Star Limo

800 Avenida Caesar Chavez, Albuquerque, NM Grading and Drainage Plan Stamp Date 11/16/2016 (File: L13/D059)

Based upon the information provided in your submittal received 11/16/2016, the above –referenced Grading and Drainage plan cannot be approved for Building Permit until the following comments are addressed:

GRADING AND DRAINAGE PLAN

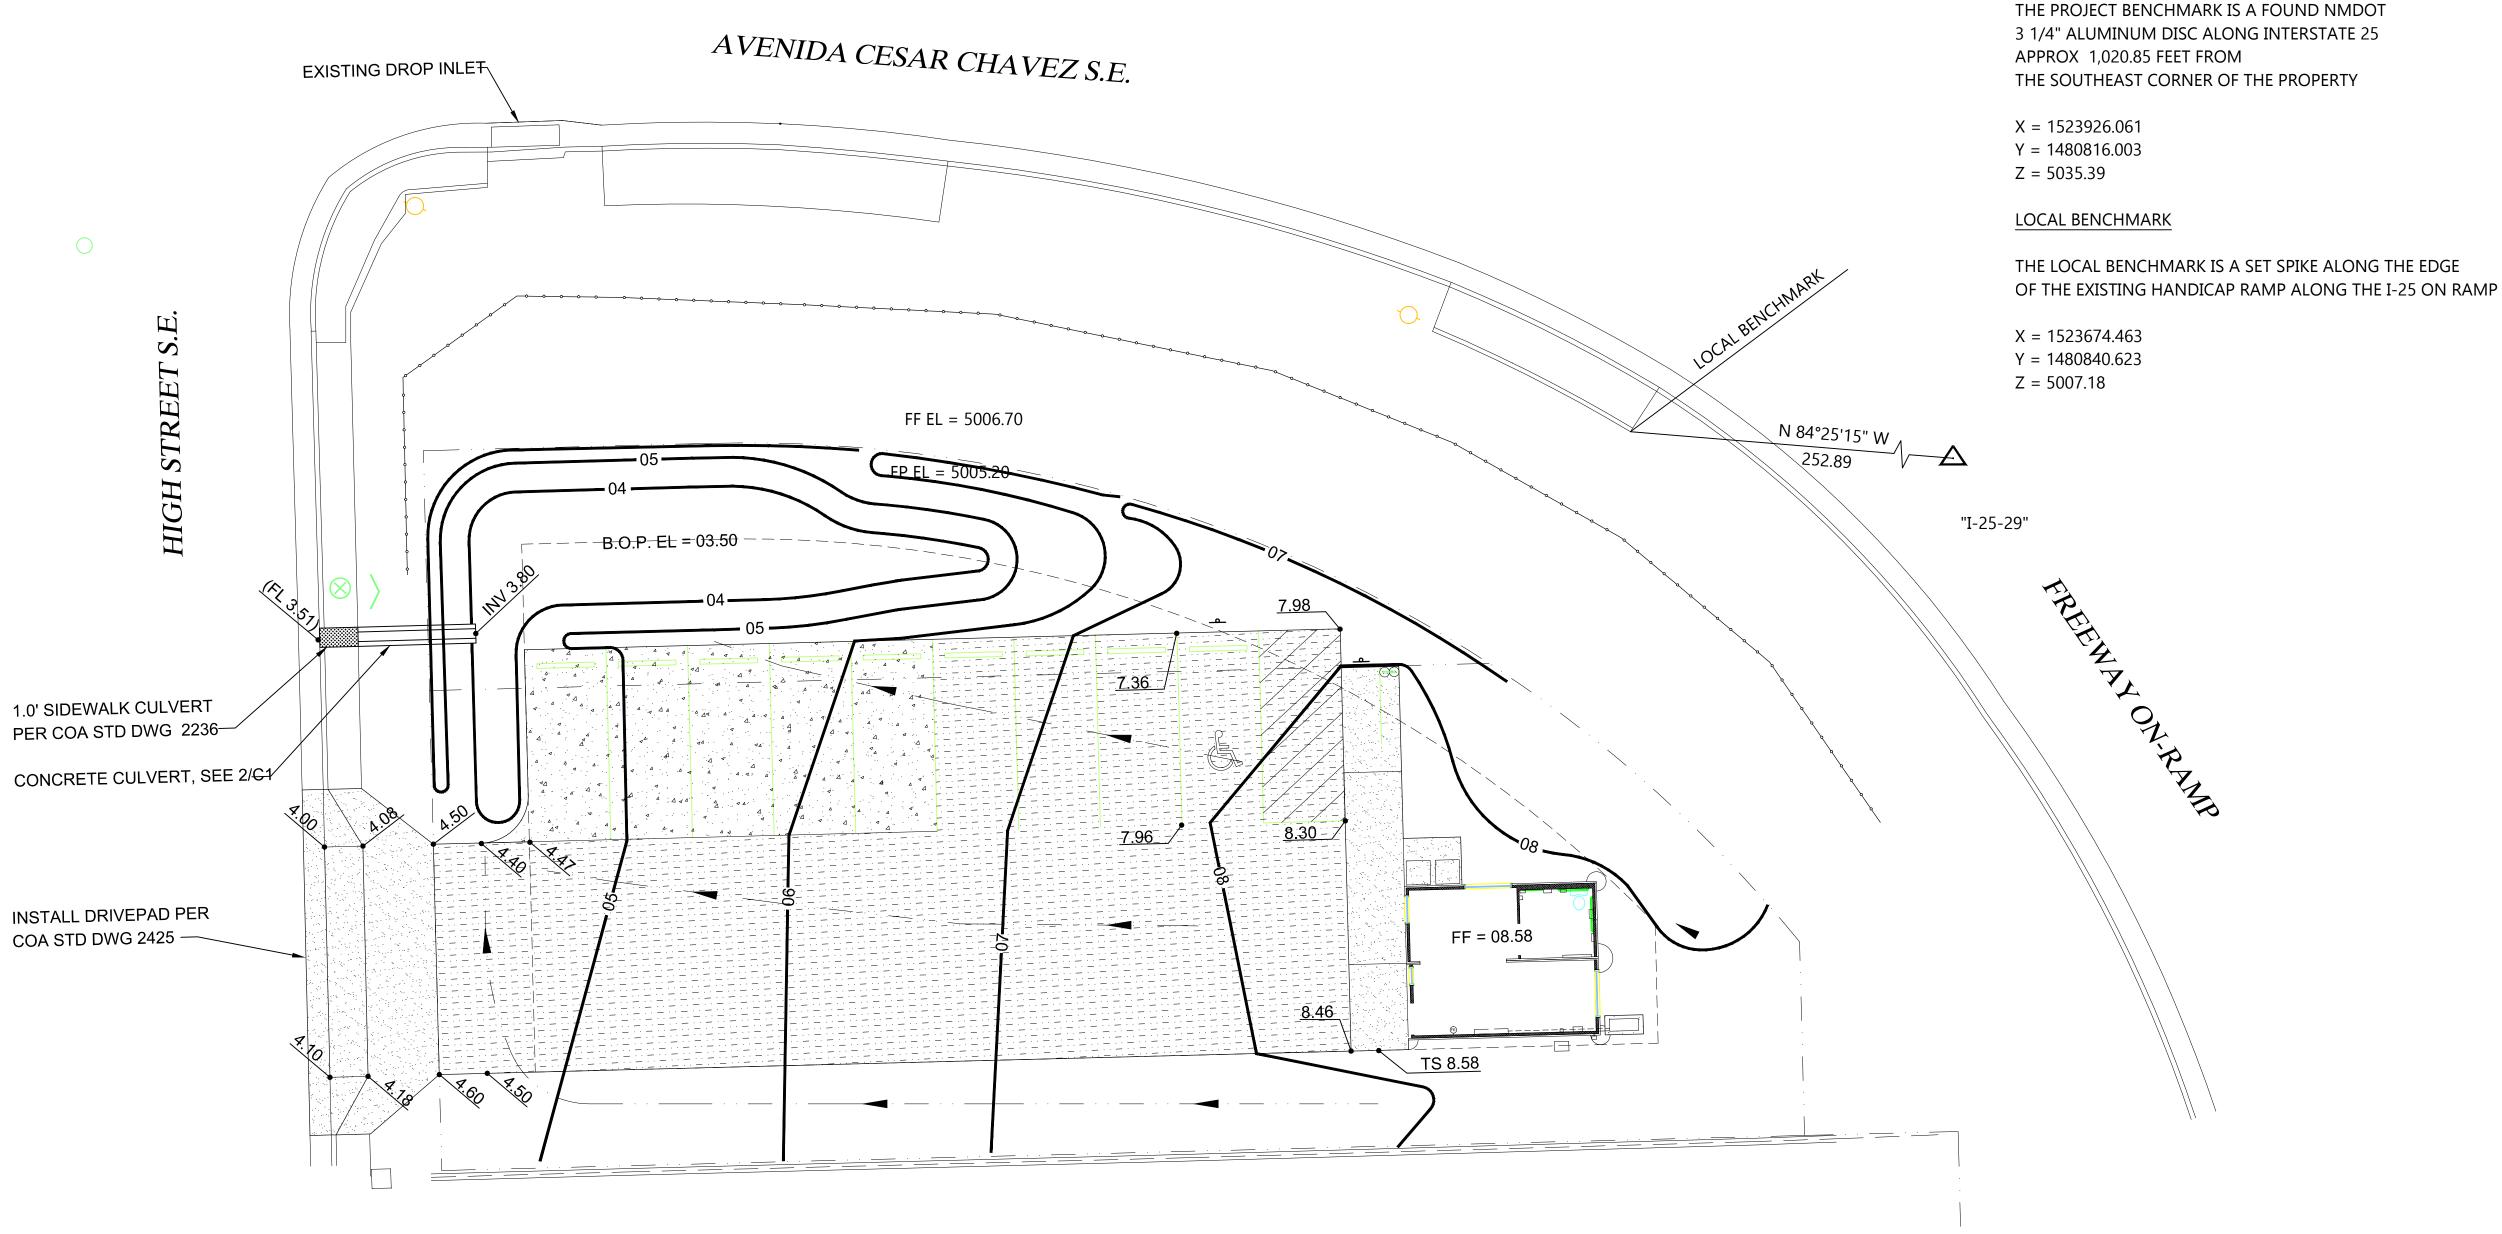
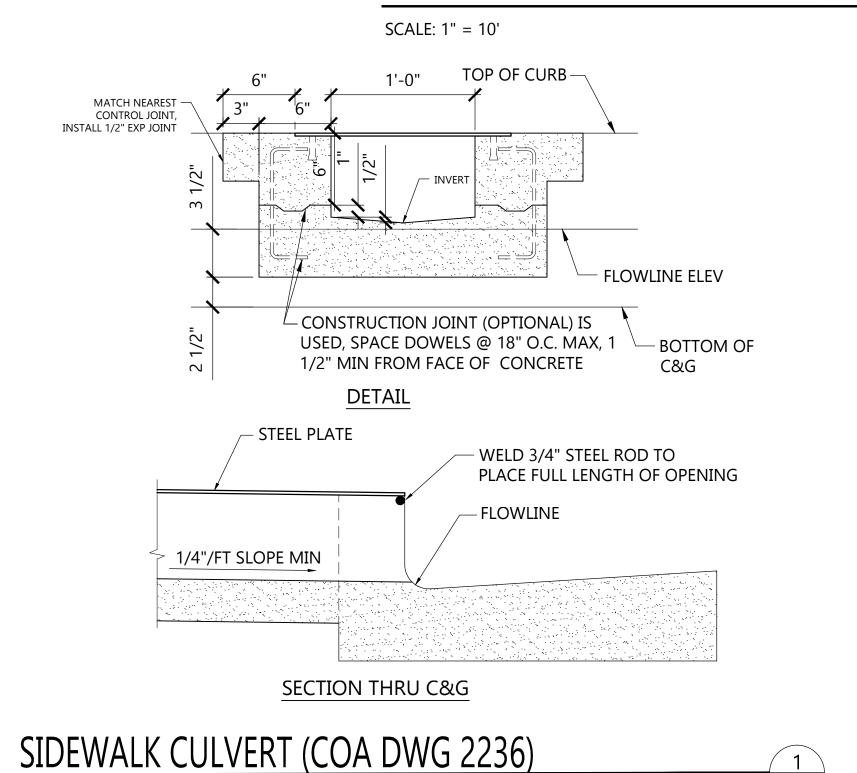
1. Provide existing spot elevations and/or contours to review the proposed grades.

2. Provide calculations for the stormwater quality volume.

- 3. It appears that a majority of the parking lot drains out the drive entrance rather than into a stormwater quality pond. If this area is impervious it is to drain to a water quality pond prior to discharging to the street.
- 4. Provide the water service elevation for the stormwater quilted volume.
- 5. Show Property Lines; does this project impact the NMDOT right of way?
- 6. Include a legend for the hatch areas.
- 7. Provide the monument for the benchmark and vertical datum.
- 8. The culvert plate needs to be extended 1-foot behind the side walk.

9. The narrative states there are three flush water ponds, when there is only one.
